**DAM SAFETY INSPECTION  
REPORT**

**GORGAS STEAM PLANT  
WALKER COUNTY,  
ALABAMA**

**PROJECT NO. 09-4157  
JULY 2009**

FIGURE 3  
RATTLESNAKE DAM  
AND FEATURES  
GORCAS PLANT  
DAM SAFETY INSPECTION  
PREPARED FOR

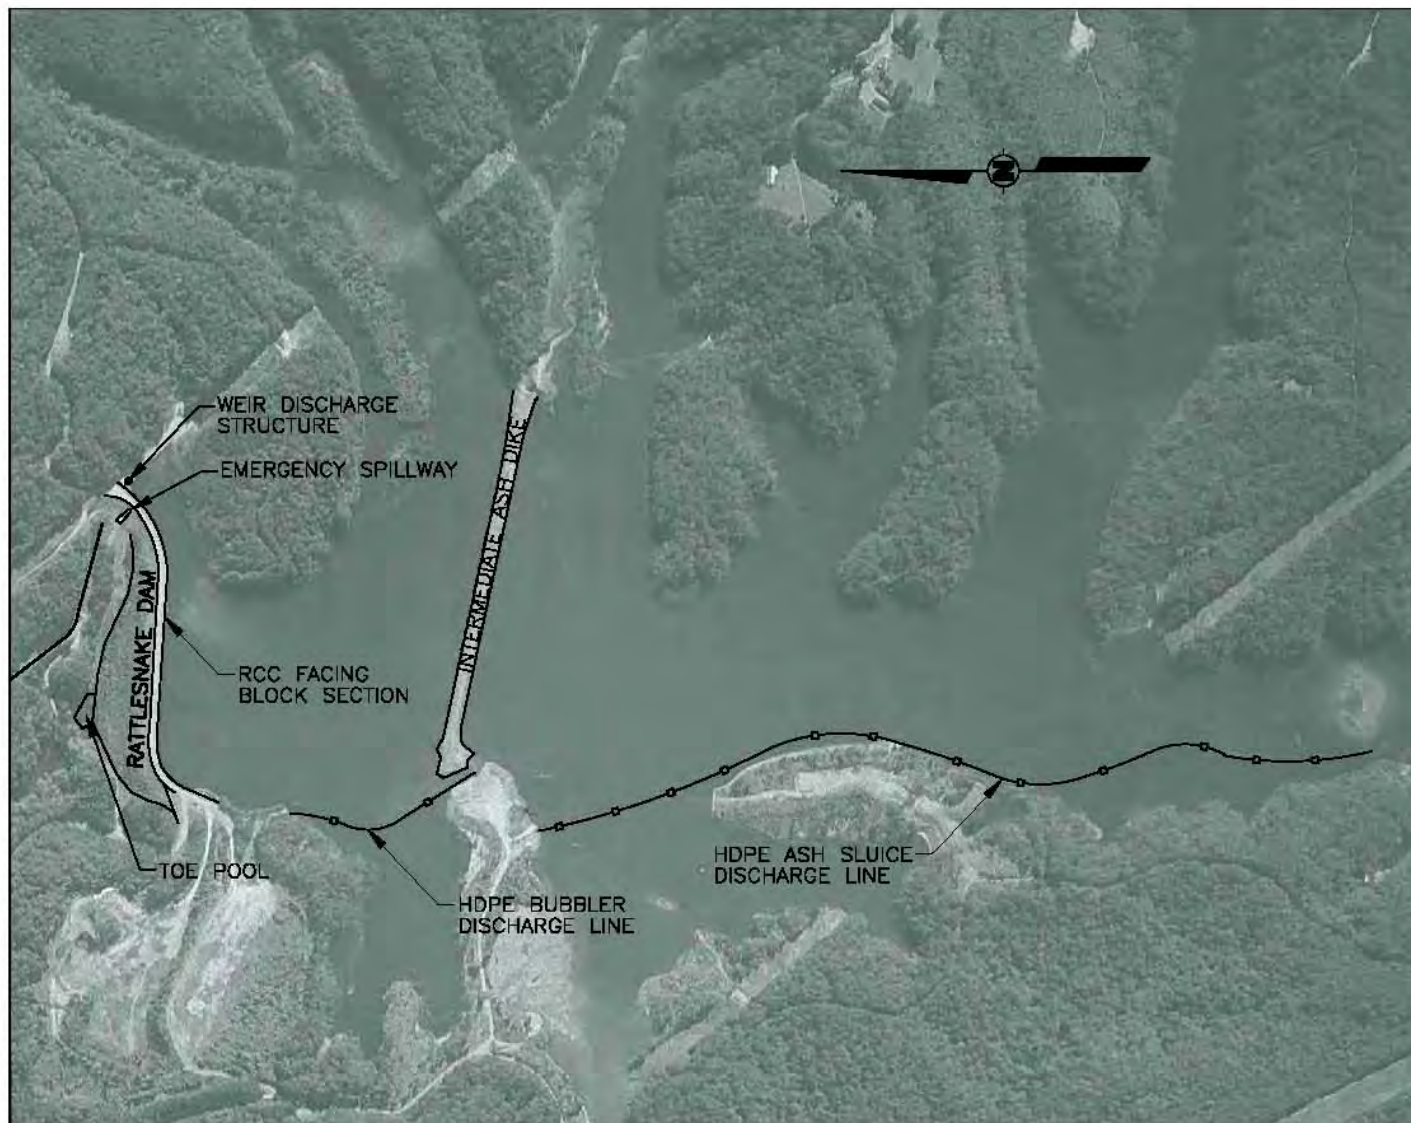
Vertical cracking was noted in the upstream face of the RCC near the intake weir and right abutment. See Photo 6. According to APC personnel, no construction joints were placed in the RCC facing between the abutments – a distance of approximately redacted. No area of concentrated vertical cracking was noted elsewhere on the RCC facing. The existing cracks should be monitored for change in size as part of the inspection program. The left abutment is flatter than the right abutment but may be subject to cracking due to future differential settlement. Observation of the front face of the RCC for cracking should be included in periodic inspection checklists.

- ① APPROXIMATE LOCATION OF SEEPAGE FROM TOE.
- ② CRACKING IN RCC FACING BLOCK NOTED HERE.

It is recommended that cracks in the RCC facing block of Rattlesnake Dam be monitored as they develop, and that remedial measures such as caulking or grouting be considered to treat the cracks if they are deemed a risk to the embankment materials during normal conditions or high pool events.
